Service Bulletin No: 53-003

**FUSELAGE - REAR FUSELAGE
STABILIZER-TRIM ATTACHMENT COMPONENTS - INSPECTION****1. Planning Information****A. Effectivity**

Pilatus PC-6 Series aircraft MSNs 337 thru 1005.

Stabilizer-trim Attachment Components - Inspection and Replacement
 (Riveted Fairchild Type was Removed by SB 53-001 Rev. 1)
 Figure 1

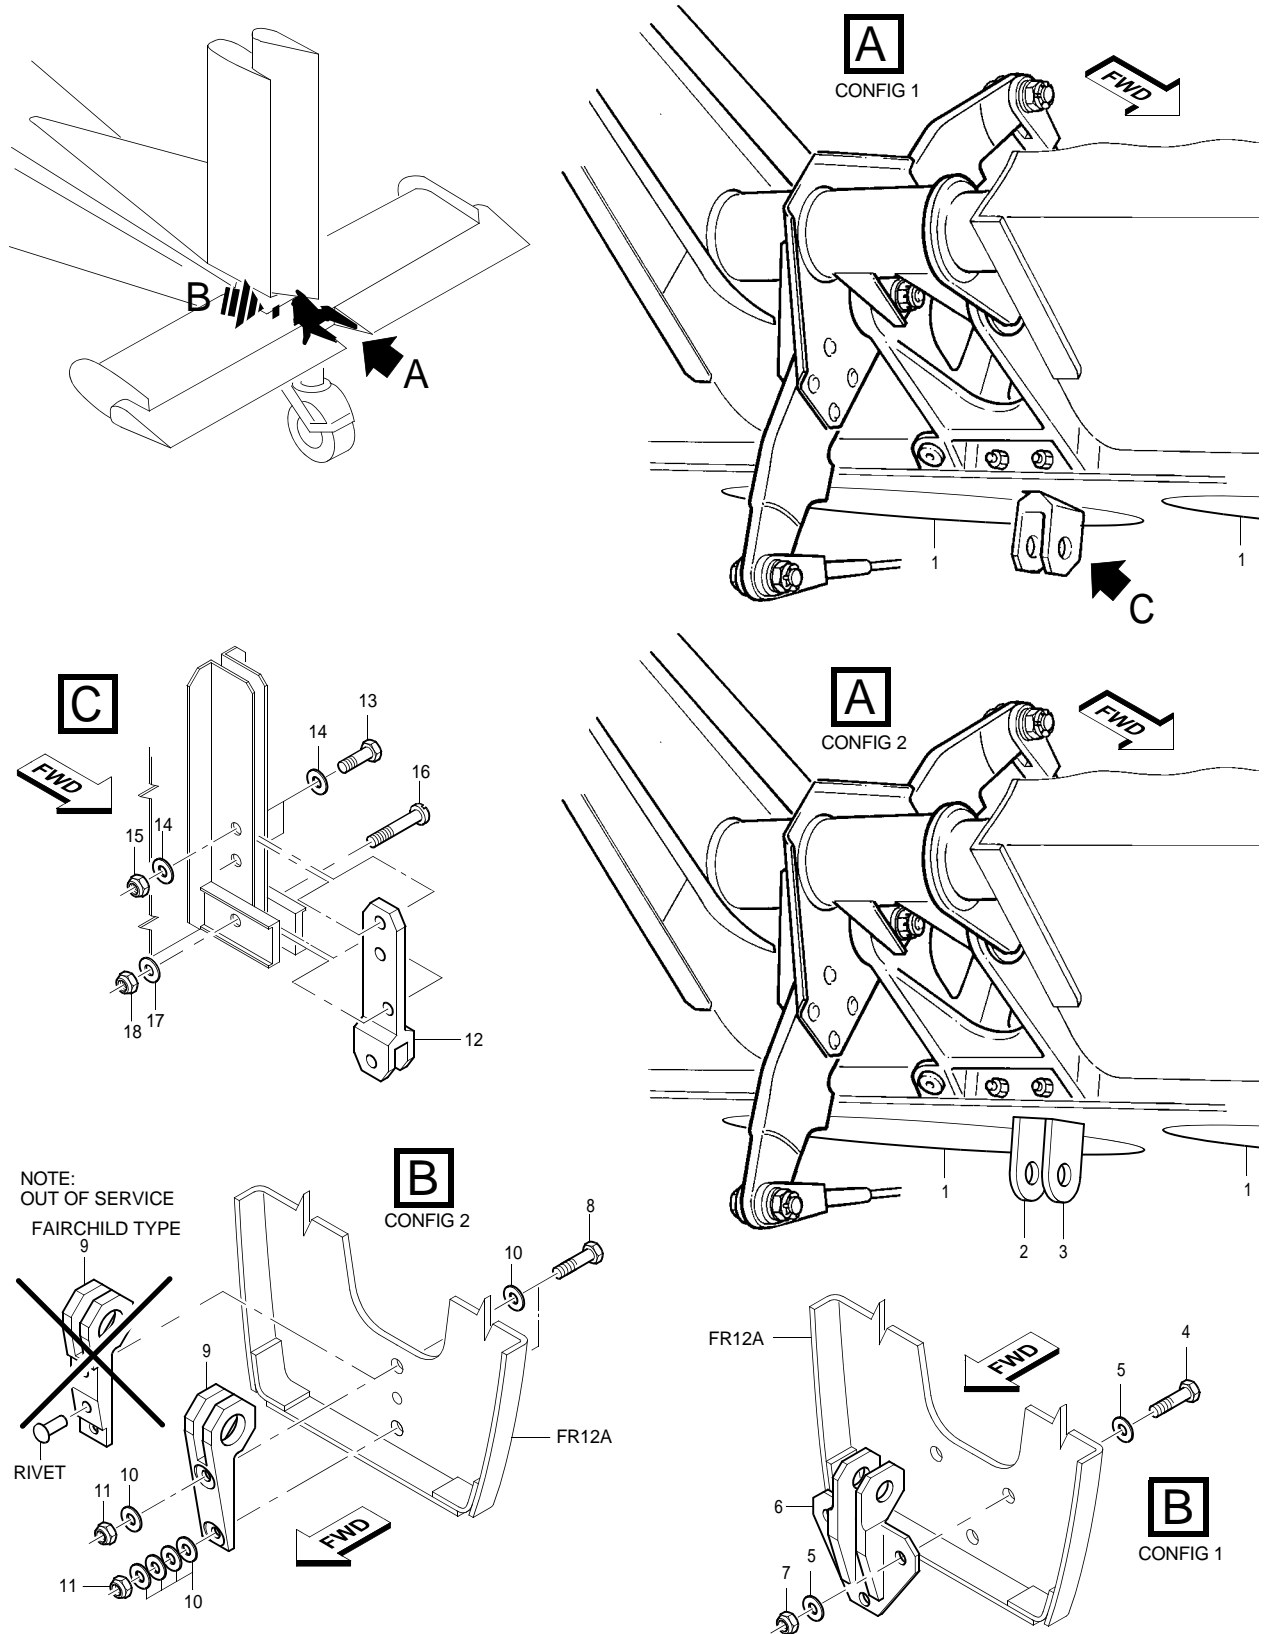
- Show the screw (16), washer (17) and nut (18) on Fig. 1 and include them in the parts lists and procedures
- Correct two cross-references on Page 10 and correct the SB reference in the title of Fig. 2.

If operators have replaced the bearing fork (Fig. 1, Item 12) in accordance with the initial issue of this Service Bulletin, they must make sure it is installed with two bolts and one screw.

- (1) CONFIG 1 Aircraft:
 - (a) Remove the nuts (7), washers (5), bolts (4).
 - (b) Remove the fitting (6) from FR12a.
 - (c) Record the part marking of the fitting (6) on the Report Form supplied with this Service Bulletin.
 - (d) Discard the fitting if it has incomplete or missing part marking, unless you can confirm the service history of the fitting from its documentation.
- (2) CONFIG 2 Aircraft:
 - (a) Remove the nuts (11), washers (10), bolts (8) and disassemble the connecting piece (9) from FR12a.
 - (b) Record the part marking of the connecting piece (9) on the Report Form supplied with this Service Bulletin.
 - (c) Discard the connecting piece if it has incomplete or missing part marking, unless you can confirm the service history of the connecting piece from its documentation.

- (d) Use internal vernier callipers (or equivalent) to do a check of the actuator attachment hole diameters in the fitting (6) (CONFIG 1) and connecting piece (9) (CONFIG 2). Hole diameters of more than 9,555 mm (0.3762 in.) in the fitting or 16.036 mm (0.631 in.) in the connecting piece are not permitted. Replace defective components (Ref. Table 1 - Component Replacement Data).

- (e) Use internal vernier callipers (or equivalent) to do a check of the diameters of the attachment bolt holes in the fitting (6) (CONFIG 1) and FR12a (CONFIG 1). Hole diameters of more than 4,85 mm (0.191 in.) are not permitted. Replace the component if defective. If necessary, also replace FR12a, if the applicable holes for the fitting are out of limits (Ref. Table 1 - Component Replacement Data).

- (f) Use internal vernier callipers (or equivalent instrument) to do a check of the diameters of the attachment bolt holes in the connecting piece (9) (CONFIG 2) and FR12a (CONFIG 2):
- If all of the hole diameters are 6,024 mm (0.23717 in.) or less, continue from Para D, Step (2)(b)
 - If one or more of the holes are more than 6,024 mm (0.237 in.) but less than 6,35 mm (0.25 in.), continue from Para D, Step (2)(c)

- If one or more holes are 6,35 mm (0.25 in.) or more, replace the connecting piece (9) and/or the FR12a (Ref. Table 1 - Component Replacement Data).

Critical Inspection Areas
Figure 3

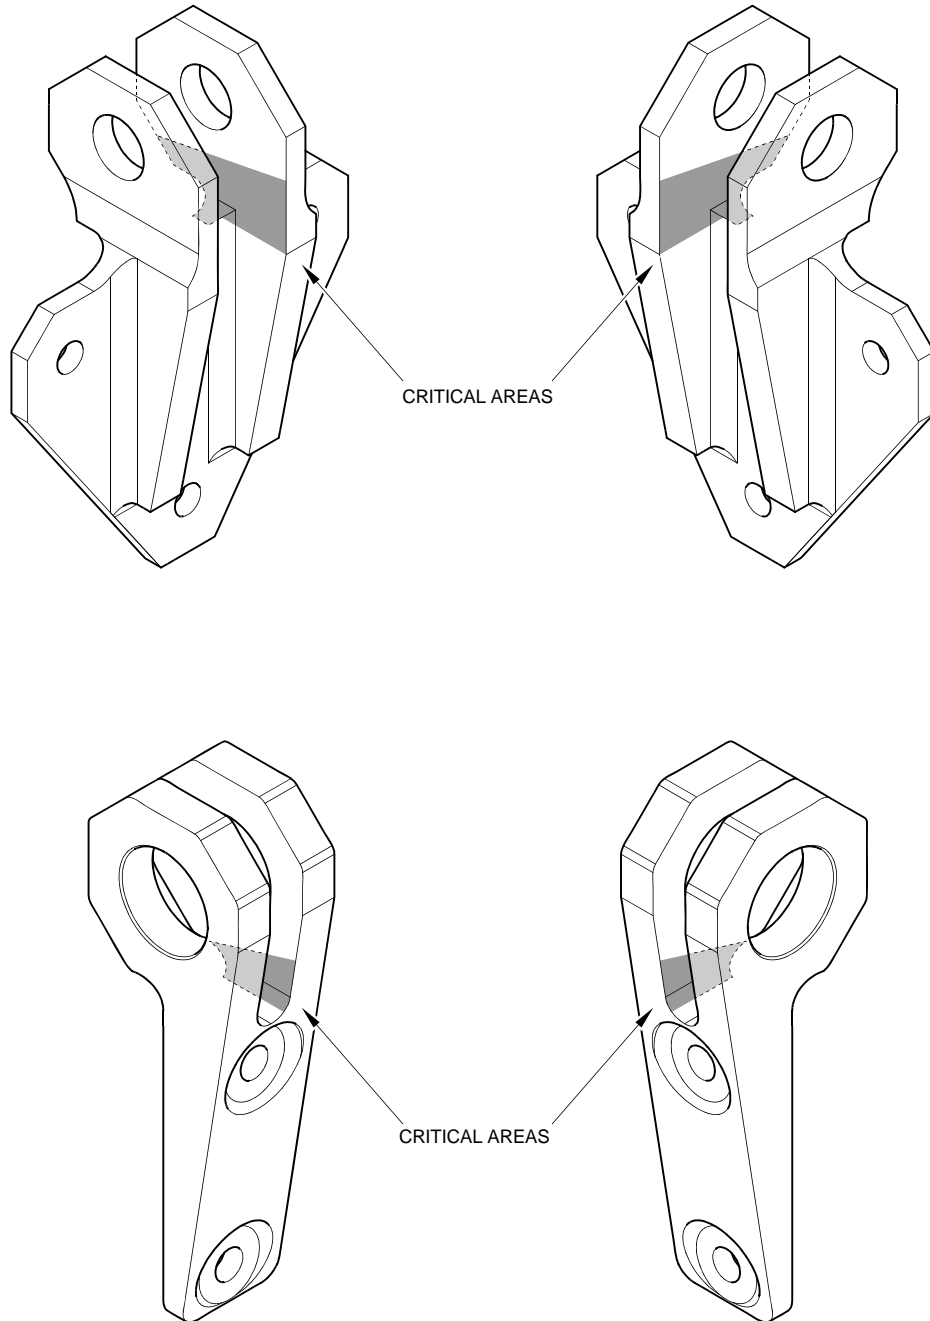
- Fitting (6) or connecting piece (9). Make sure you do a thorough inspection of the critical areas shown on Figure 3
- Bearing fork (12) or bearing supports (2) and (3)
- Applicable area of FR12a.
